RACINE ST, EAST 22ND AVE,
AND REVERE ST
INFRASTRUCTURE SITE PLAN
FITZSIMONS INNOVATION COMMUNITY FILING NO. 2
GRADING & UTILITY PLAN

No.	Description of Revisions	Date	Name
1	1ST ISP/CSP SUBMITTAL TO COA	11/15/19	JTA
2	2ND ISP/CSP SUBMITTAL TO COA	02/21/20	JTA
3	3RD ISP SUBMITTAL TO COA	02/17/21	JTA
4	4TH ISP SUBMITTAL TO COA	06/25/21	JTA

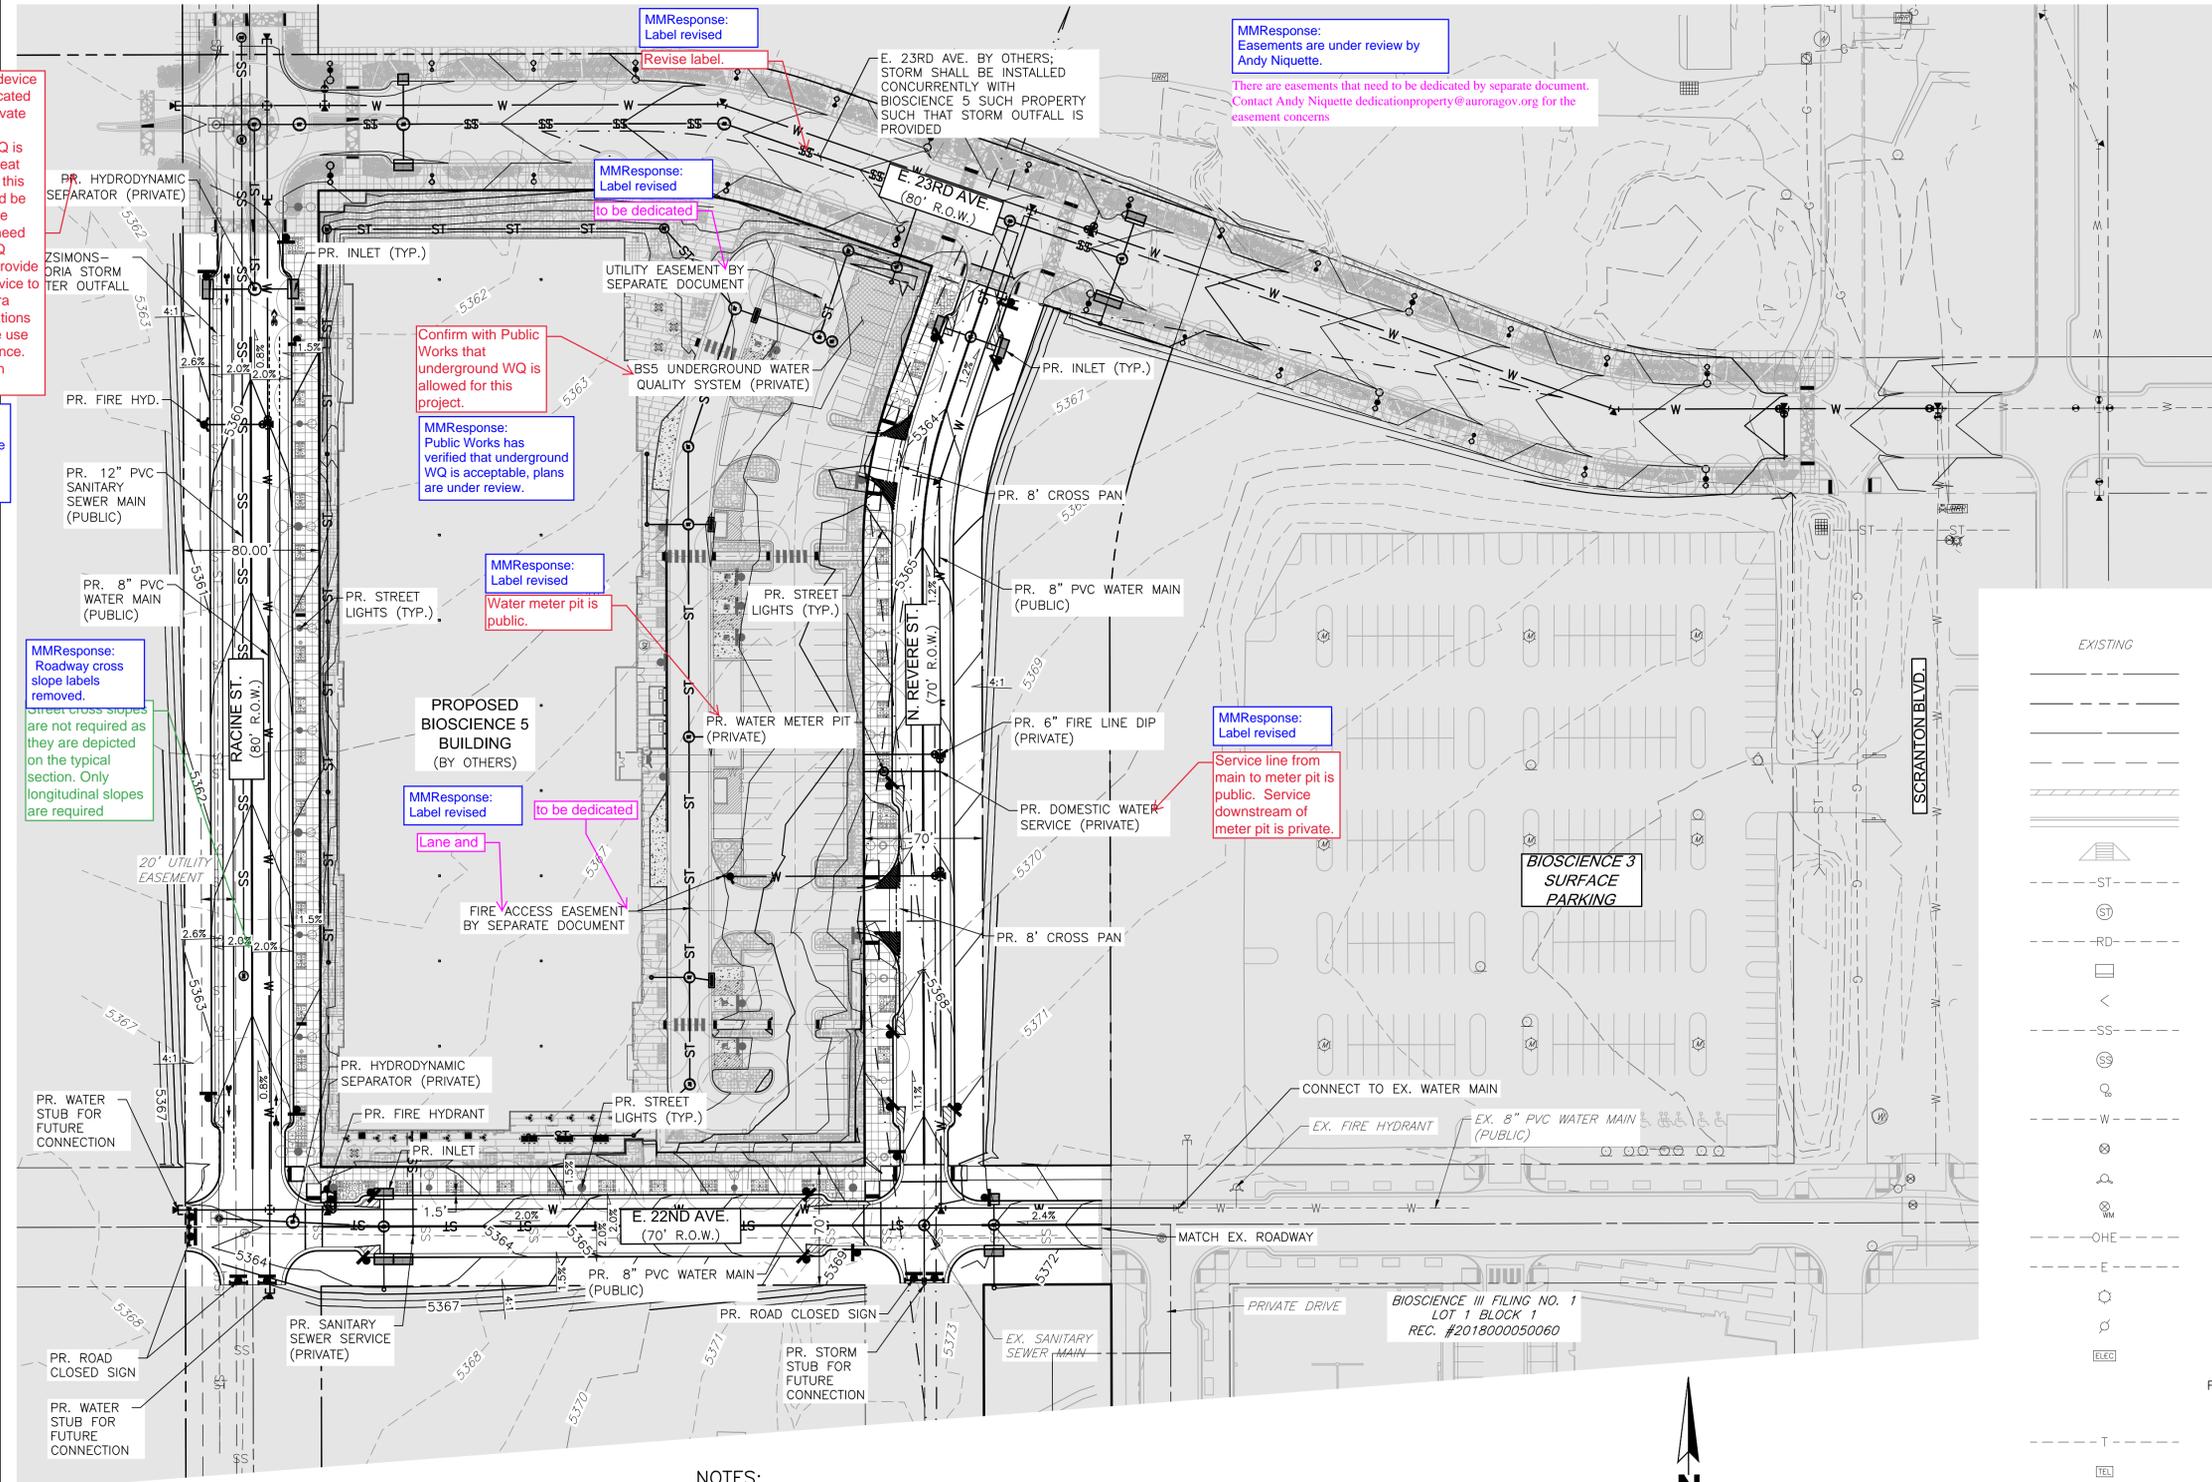
Private WQ device should be located within the private storm sewer system. If WQ is required to treat ROW runoff, this device should be public. Please confirm the need for public WQ device and provide proposed device to ensure Aurora Water Operations approves the use for maintenance. (typ all WQ in ROW)

Confirm with Public Works that underground WQ is allowed for this project. MMResponse: Public Works has verified that underground WQ is acceptable, plans are under review.

MMResponse: Storm sewer system is labeled according to the preliminary drainage report COA review comments.

MMResponse: Roadway cross slope labels removed. Street cross slopes are not required as they are depicted on the typical section. Only longitudinal slopes are required

MMResponse: Label revised. Water meter pit is public.

MMResponse: Label revised. Lane and to be dedicated

MMResponse: Easements are under review by Andy Niquette. There are easements that need to be dedicated by separate document. Contact Andy Niquette dedicationproperty@auroragov.org for the easement concerns

MMResponse: Label revised. Service line from main to meter pit is public. Service downstream of meter pit is private.
